CONTRACT CHANGE ORDER NO. ____
SHEET ___ OF ___

MARK	DATE	DESCRIPTIONS	BY	CH'D	CCO#
3	02/04/11	BIKEPATH STUD ISSUE	TH	JD	186
2	11/12/10	BIKEPATH HANDRAIL MODIFICATIONS	TH	JD	169
1	08/20/10	BIKEPATH DETAILS	CC	TH	99

SAN FRANCISCO OAKLAND BAY BRIDGE
EAST SPAN SEISMIC SAFETY PROJECT
SELF-ANCHORED SUSPENSION BRIDGE
(SUPERSTRUCTURE & TOWER)

BIKEPATH FRAMING DETAILS NO.2

BIKEPATH DETAILS NO. 4

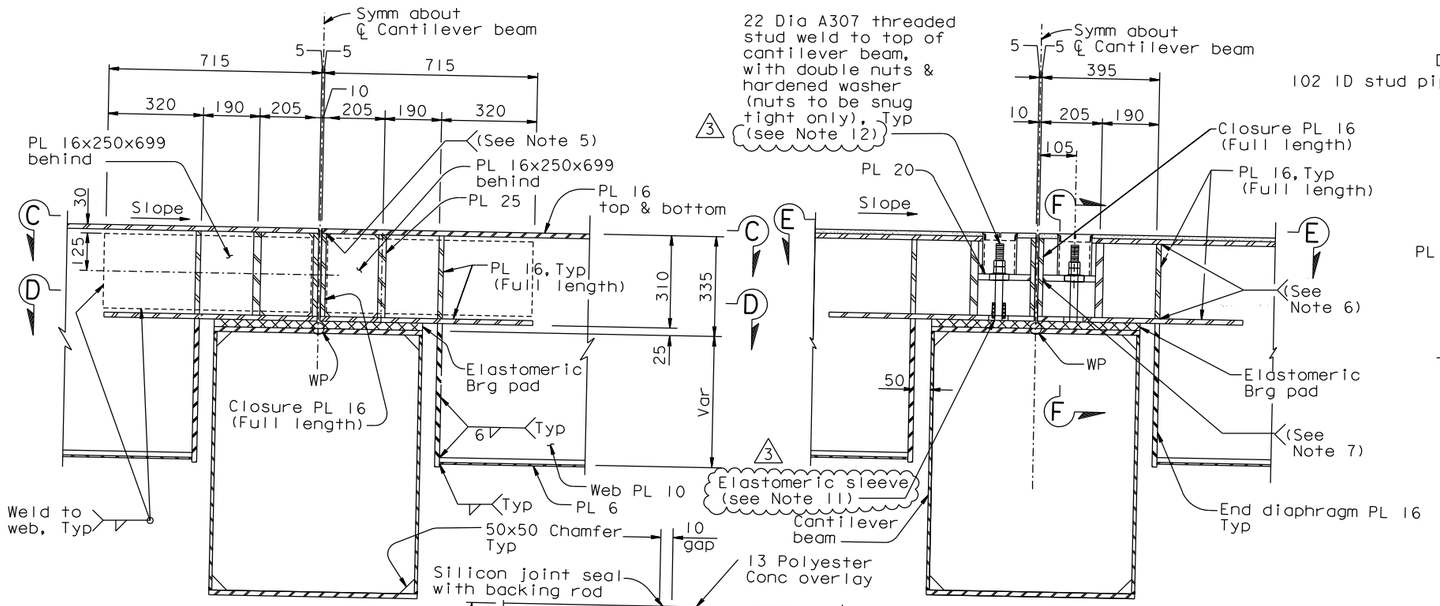
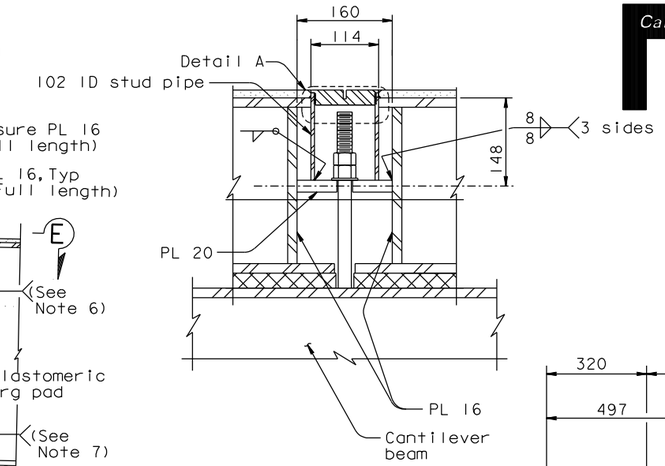
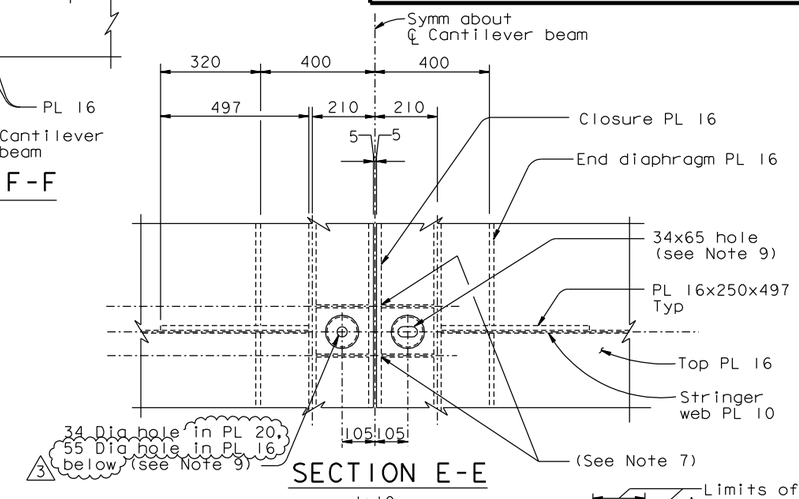
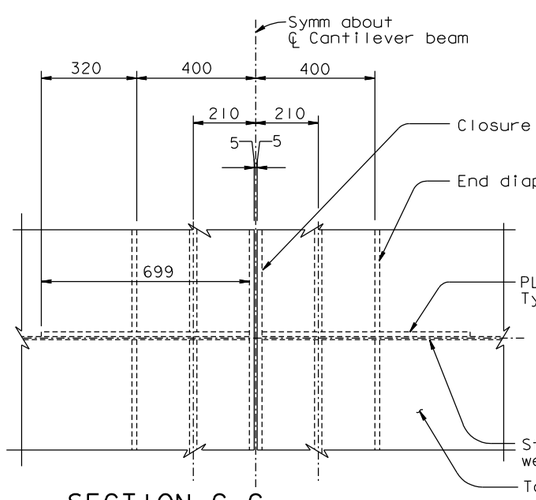
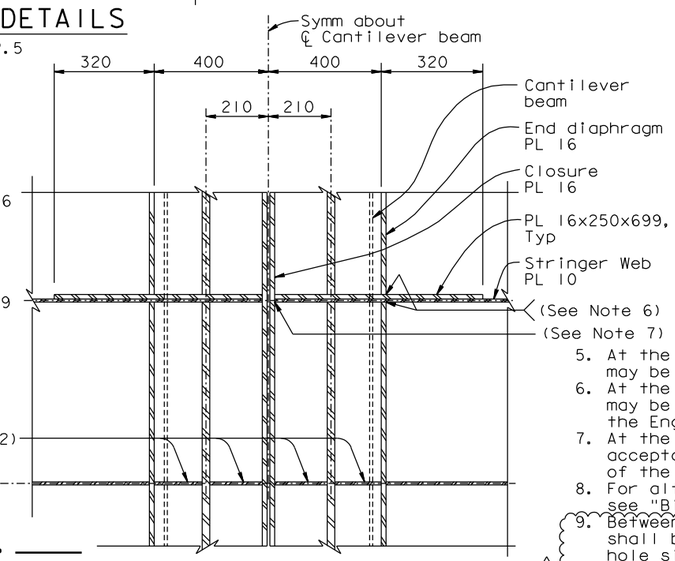
11. For elastomeric sleeve detail, see "Bikepath Details No.4A" sheet.
12. ASTM A108 Grade C1018, with mechanical properties conforming to that of Type B Studs in AWS D1.1 Table 7.1, may be used in lieu of ASTM A307.

MARK	DATE	DESCRIPTIONS	BY	CH'D	CCO#
3	02/04/11	BIKEPATH STUD ISSUE	CC	TH	186
2	08/20/10	BIKEPATH DETAILS	CC	TH	99
1	07/24/09	BIKEPATH DETAILS	CC	TH	99

BIKEPATH DETAILS NO. 17

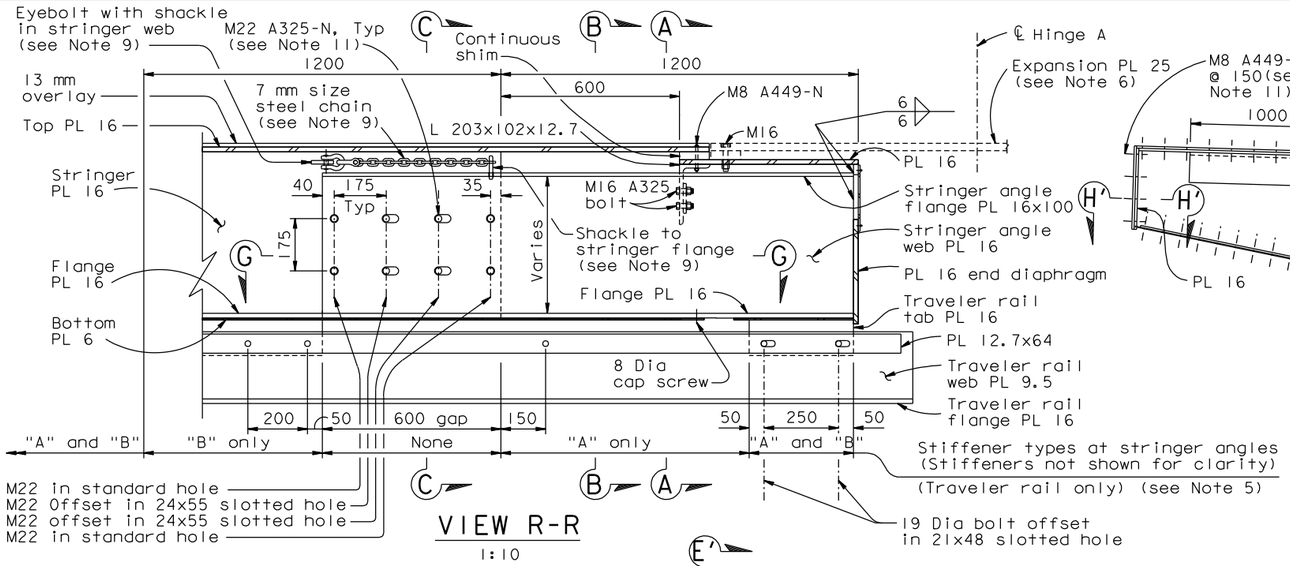
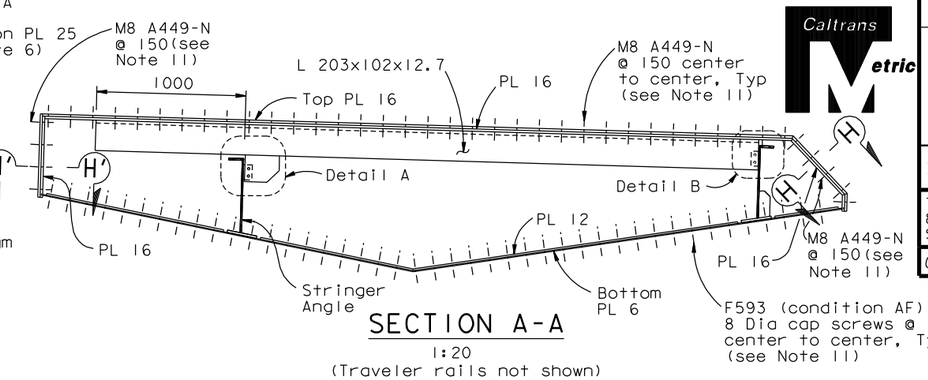
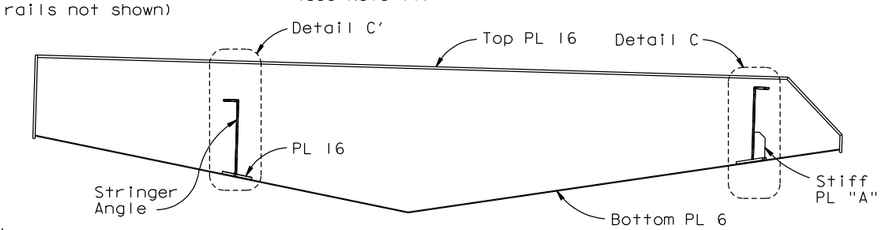
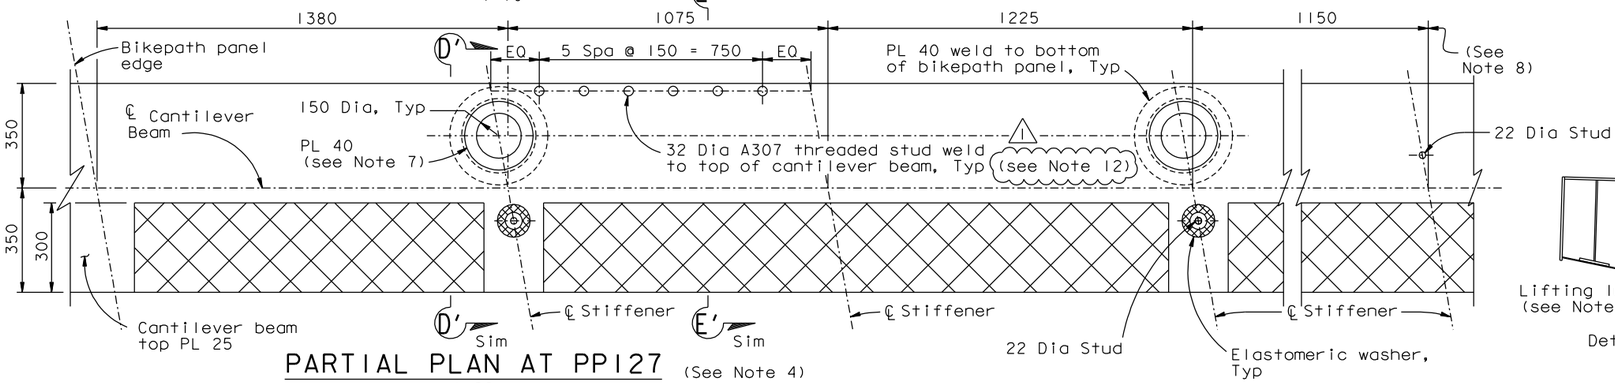
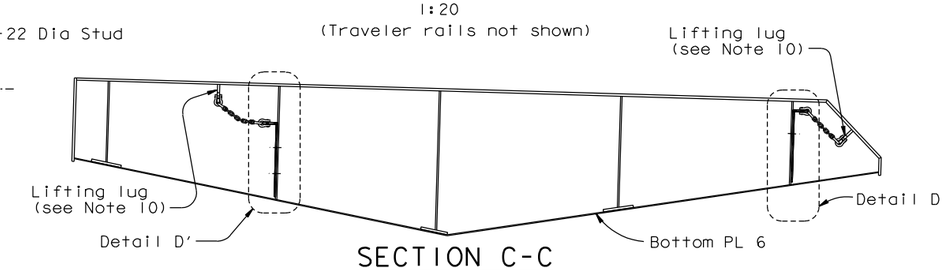
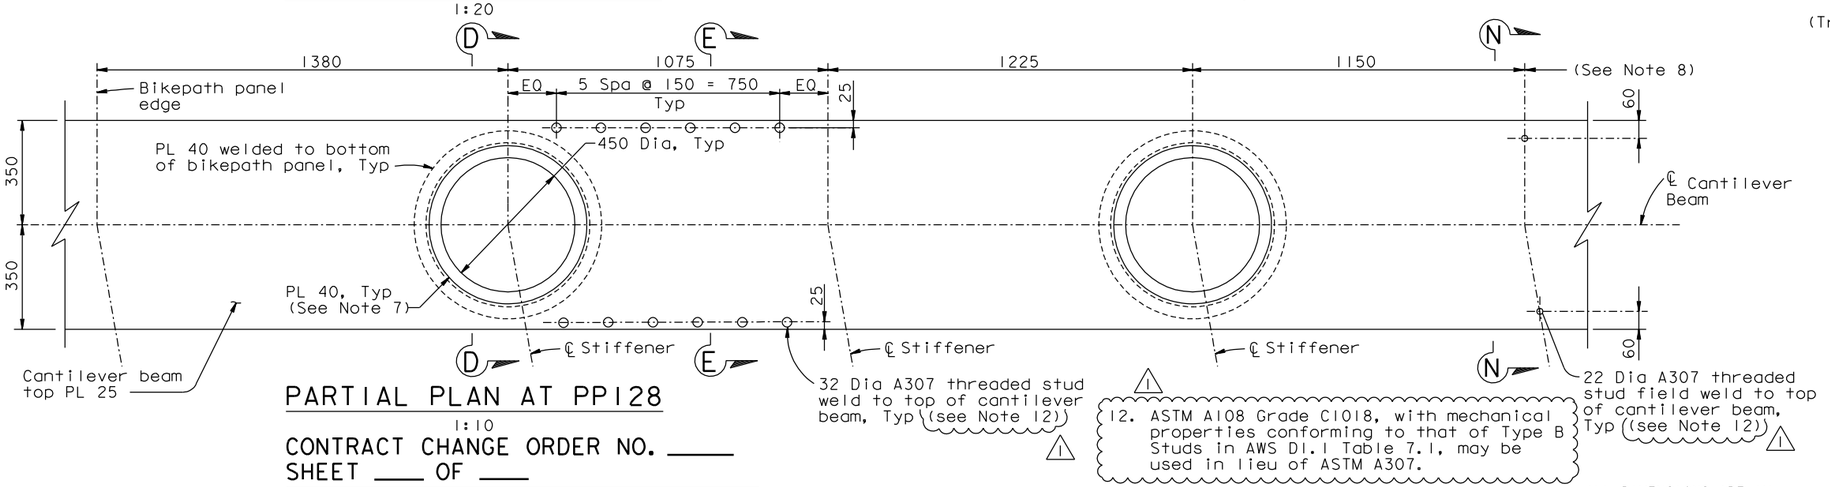
12. ASTM A108 Grade C1018, with mechanical properties conforming to that of Type B Studs in AWS D1.1 Table 7.1, may be used in lieu of ASTM A307.

MARK	DATE	DESCRIPTIONS	BY	CH'D	CCO#
1	02/04/11	BIKEPATH STUD ISSUE	CC	MN	186
0	08/20/10	BIKEPATH DETAILS	RB	MN	99
